TEMPORARY CHANGE TO OPERATING LICENSE
NO. NPF-2 AND NPF-8 TECHNICAL SPECIFICATIONS

TEMPORARY CHANGE TO OPERATING LICENSE
NO. NPF-2 AND NPF-8 TECHNICAL SPECIFICATIONS

SAFETY EVALUATION FOR CHANGE
TO THE A.C.SOURCES - OPERATION
TECHNICAL SPECIFICATION

FIGURE B.3-3

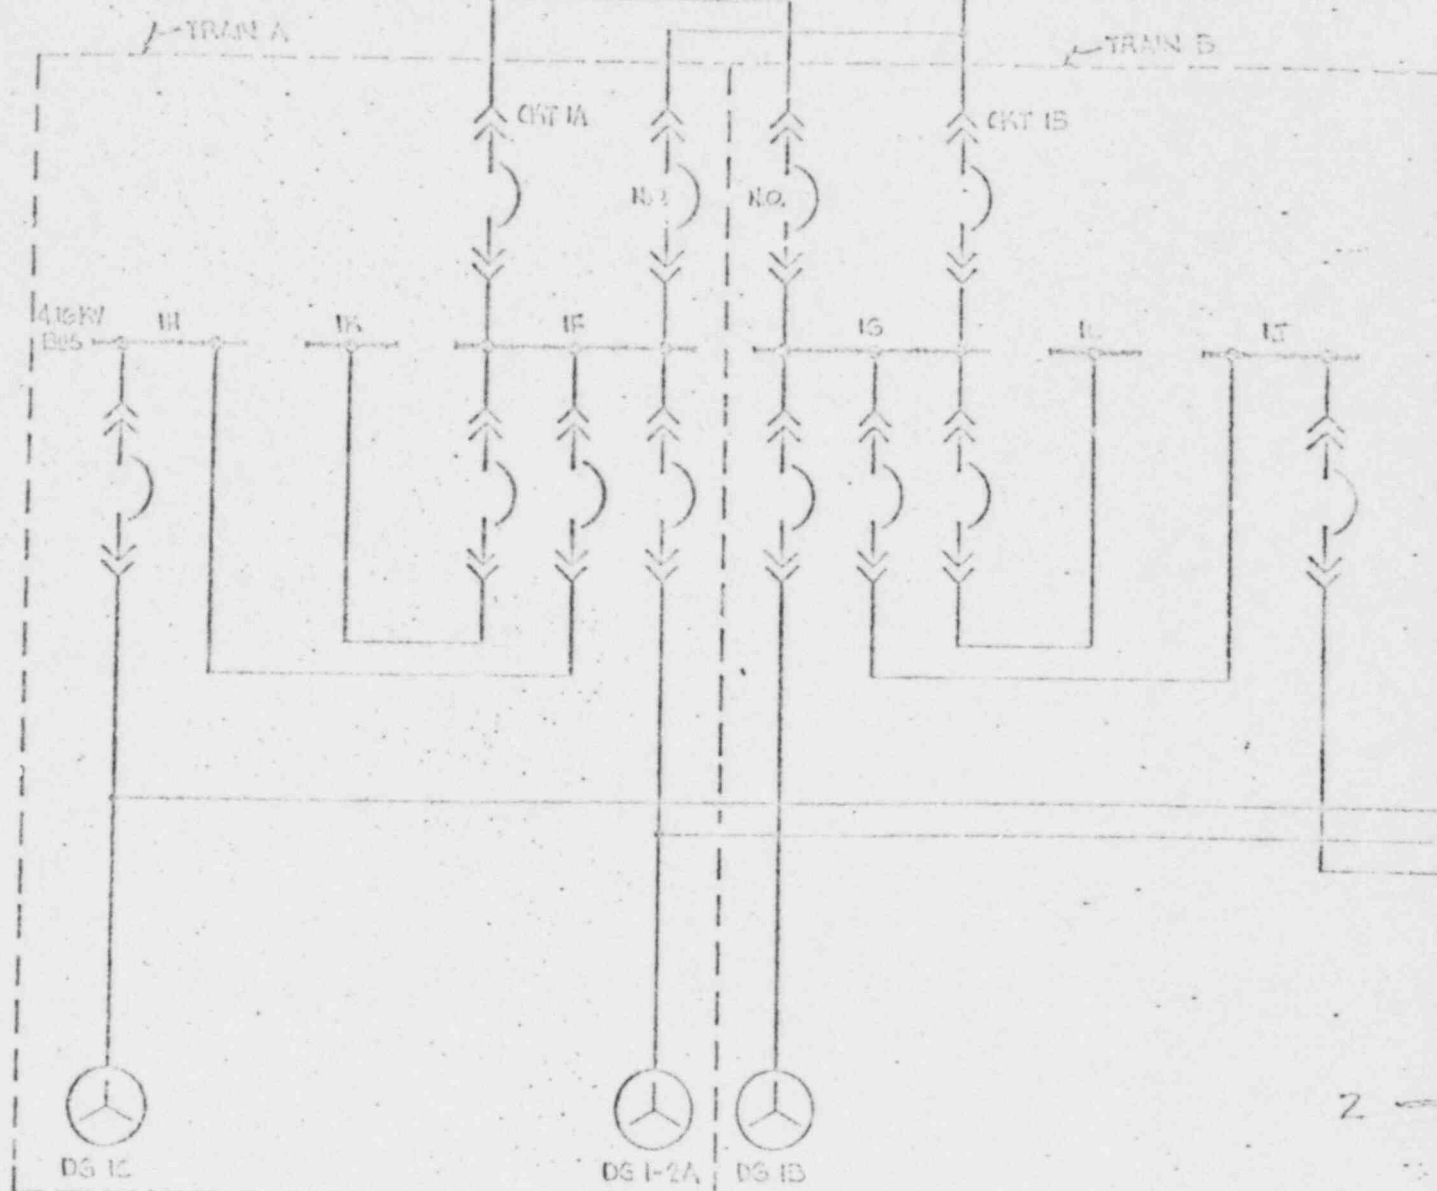
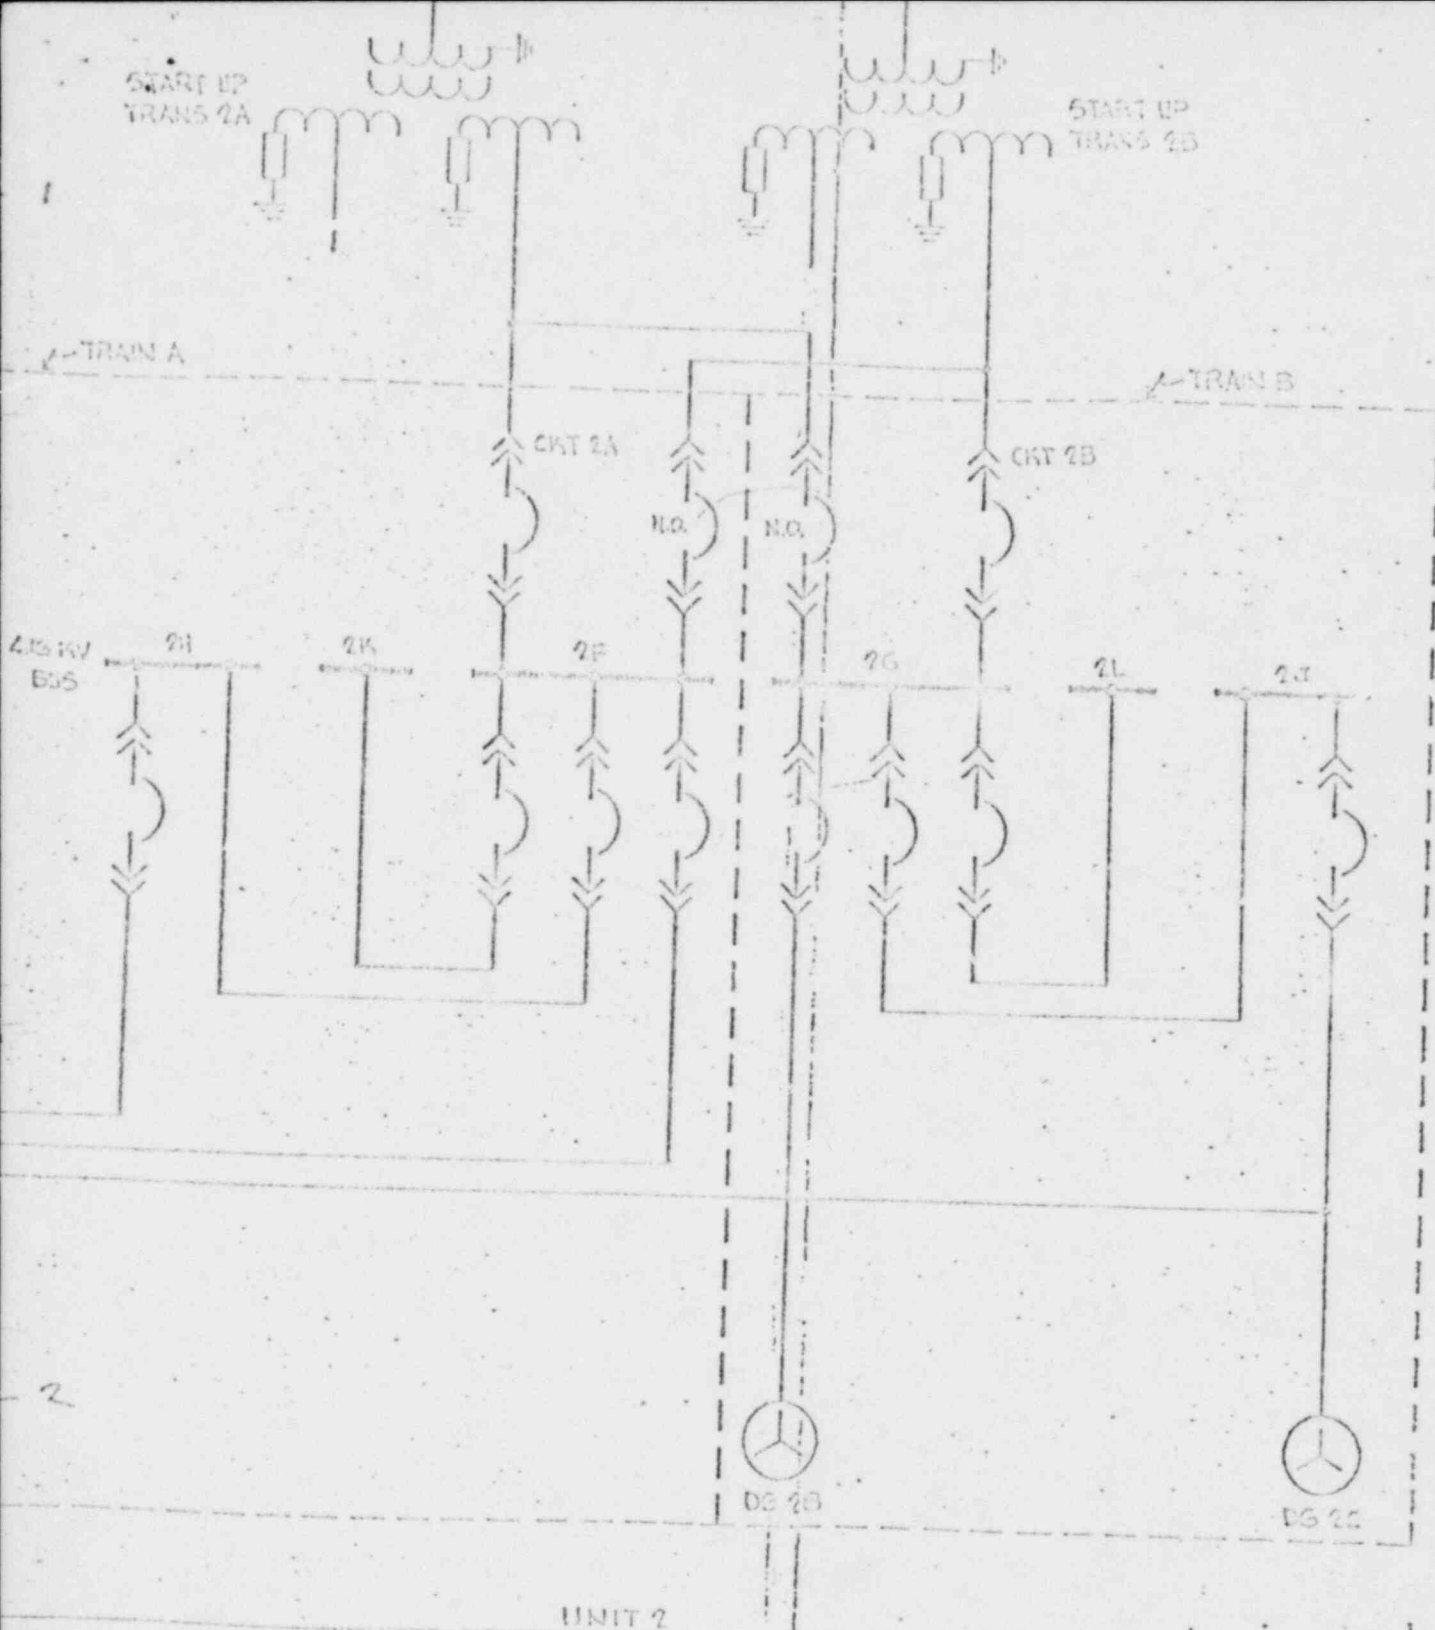
Diesel generator 1B is uniquely assigned to Unit 1, while diesel generator 2B is uniquely assigned to Unit 2. Diesel generators 1-2A, 1C and 2C are shared between the two units. See attached FSAR Fig. 8-3.3.

The loss of diesel generator 1C has no impact on either unit for case 2, 3, 6 or 7 due to the fact that D.G. 1-2A loads the essential buses and D.G. 1C does not pick up any emergency buses. The loss of D.G. 1C for case 1 results in a loss of Train A loads for Unit 2. The loss of D.G. 1C for cases 4 or 5 results in a loss of Train A loads for Units 2 or 1 respectively.

For the cases where there is a loss of coolant accident for either unit, D.G. 1-2A aligns itself to the unit which is undergoing a LOCA.

Figure 1 provides a description of the Farley emergency electrical distribution loops.
